Subject: ABWR postulated Pipe Break Dynamic Nonlinear Time History Analysis

SUBJECT: ABWR POSTULATED PIPE BREAK DYNAMIC NONLINEAR
TIME HISTORY ANALYSIS

RESPONSES TO AUDIT COMMENTS (Prepared by Henry Hwang) 4 Hwang 9/1/91

Figure 2 : Impact force at the pipe's whip restraint. DT=0.001 sec
(pa=373,600 lb, max impact=670,000 lb)

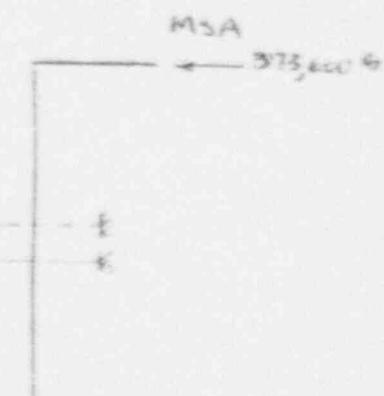
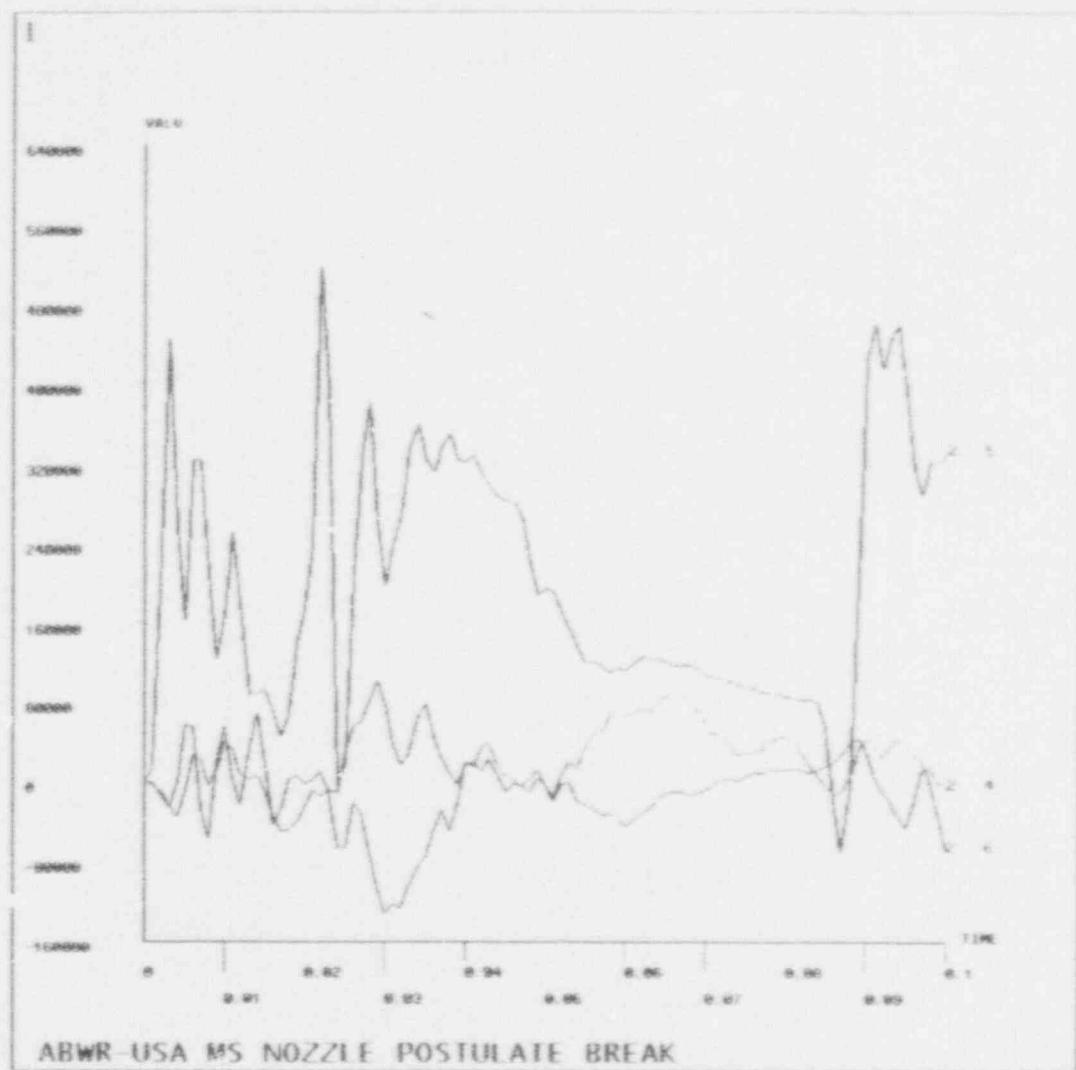
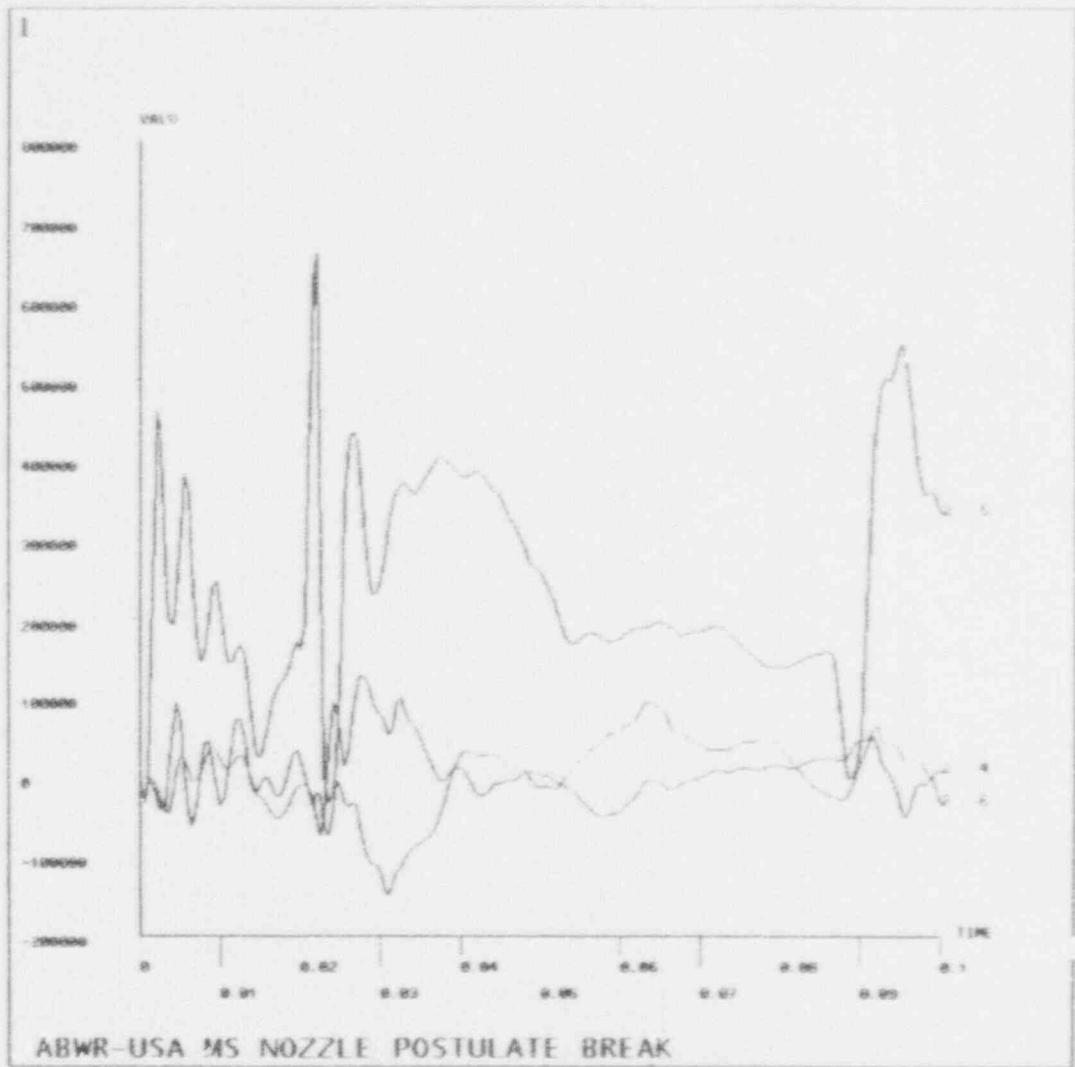
The time step used in the Main Steam Break Structure (MSBS) analysis is 0.001 second. In order to prove the convergency of the solution, GE agreed to use 0.0005 second time steps in a repeat of the analysis.

In order to show that the analysis time step 0.001 second is adequate, an analysis with time step of 0.0005 second has been performed. The results of the analysis are plotted in the following figures. Comparisons of the results between 0.001 sec and 0.0005 sec time step showed that the differences are less than 3%. Therefore, time step of 0.001 sec can be used in future analysis.

Figure 9 : Bending moment time histories. DT=0.001 sec.
at Elm 38I, 1st elm after MSIV.

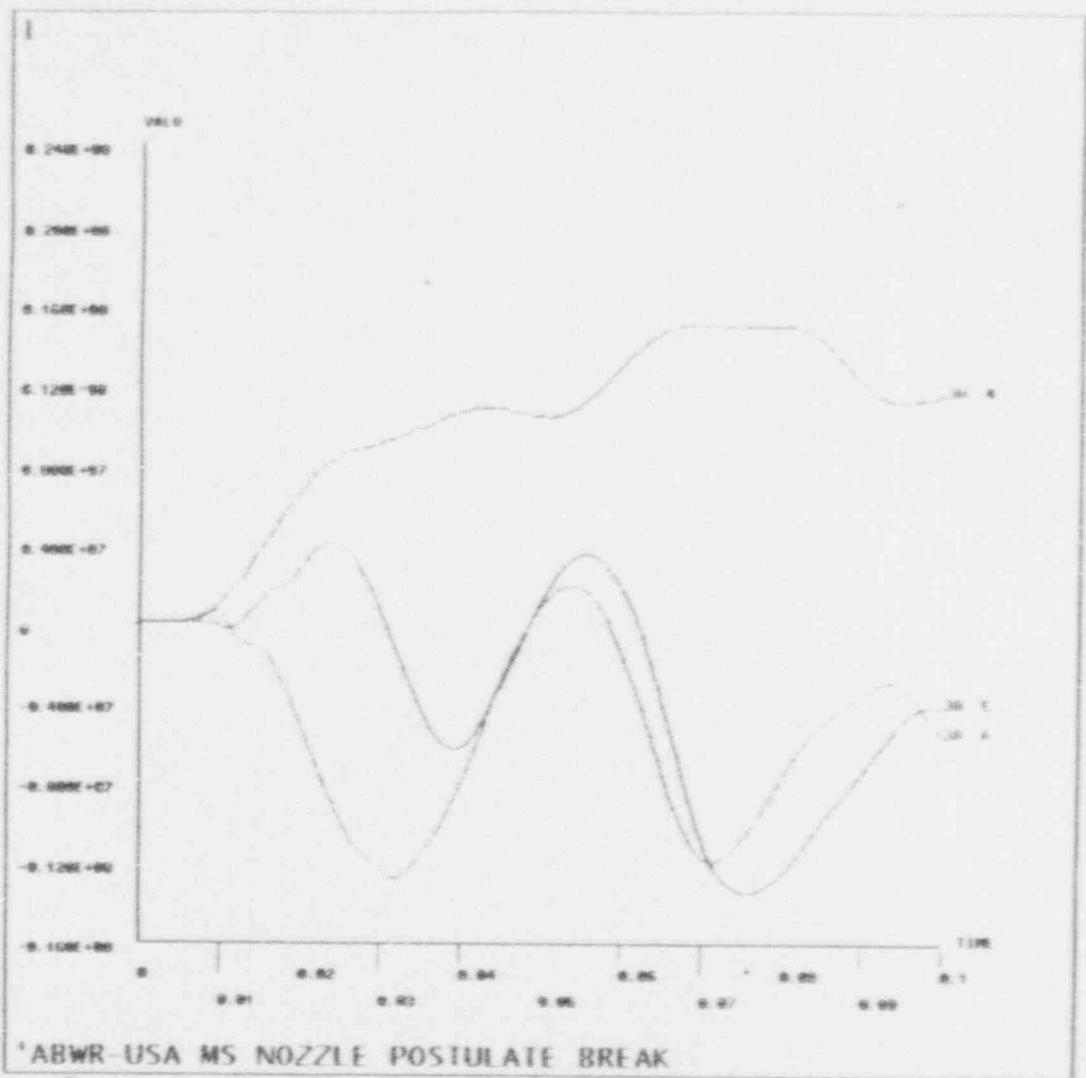
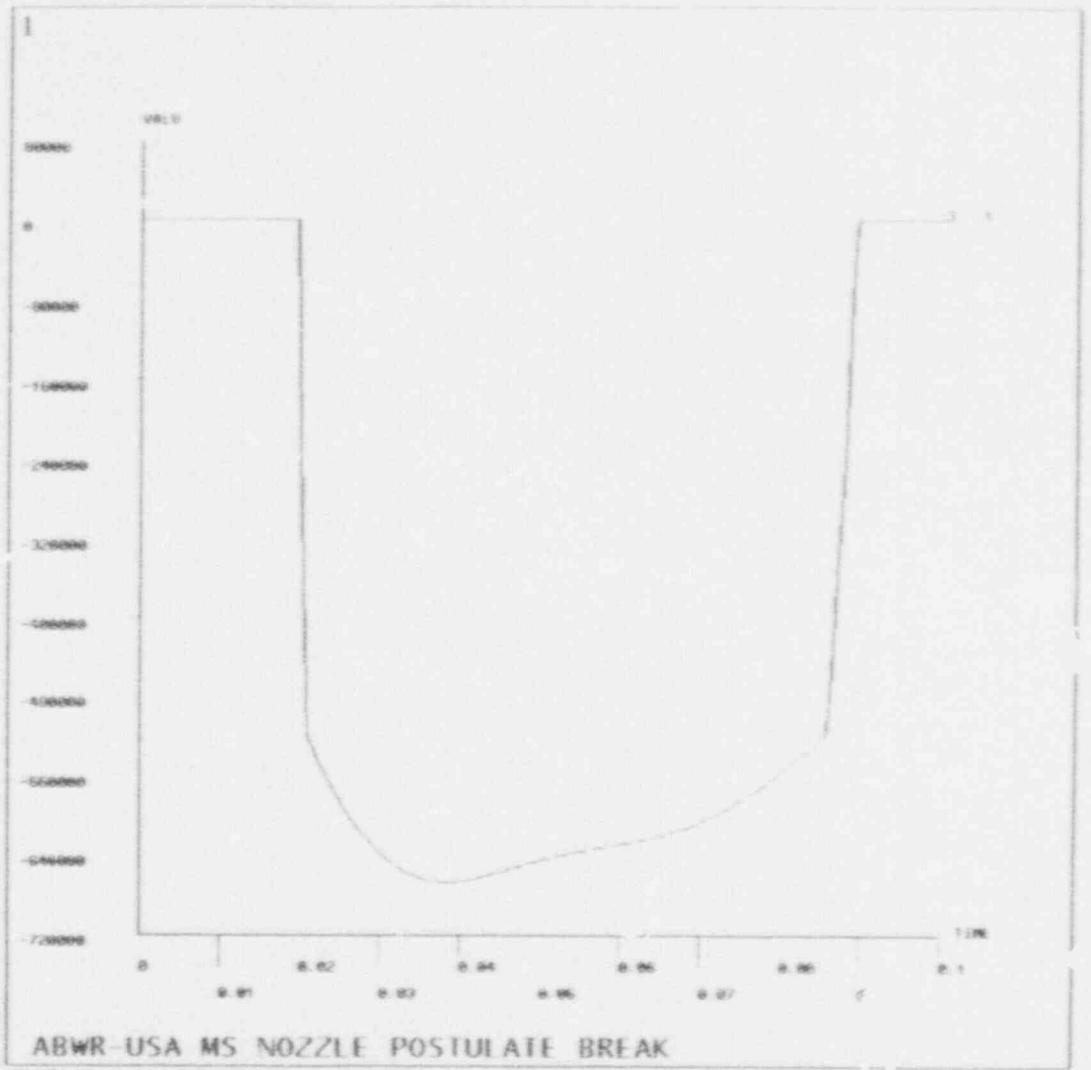
The displacements from the terminal end Main Steam Break Structure (MSBS) analysis (using ANSYS) results shows large displacements and rotation at the break. The thrust direction changes during the event which could affect the stress in the "Holy Pipe" area. Therefore, GE will use static elastic analyses for the original and displaced position to confirm the validity of the small displacement assumption in the non-linear time history analysis results.

This can be seen that the values calculated from the result 1 is slightly conservative. From Figure 9, moment time history plots at element 38I, the first element after MSIV, the maximum bending are as follows:

Ma (E6)	Mb (E6)	Mc (E6)	Mr (E6)	B2 M/Z psi
38I	15.0	13.0	11.5	22.94	30,600

This shows that the maximum stress between isolation valve is at the headfitting. The combined stress is as follows:
